New Lanyard Switches

Models Covered
Jet Drive/Mercury/Mariner

Old vs. new lanyard
a - 87-19674Q2
b - New style

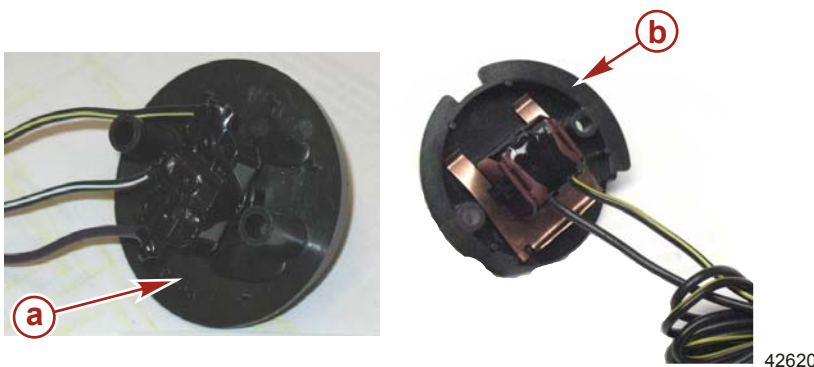
Mercury Marine has created a new waterproof lanyard switch with two different mounting options; flush mount or bezel mount with two inch cut out.

Part number 87-19674Q2 will no longer be available. Please use the chart below to find the correct switch application.
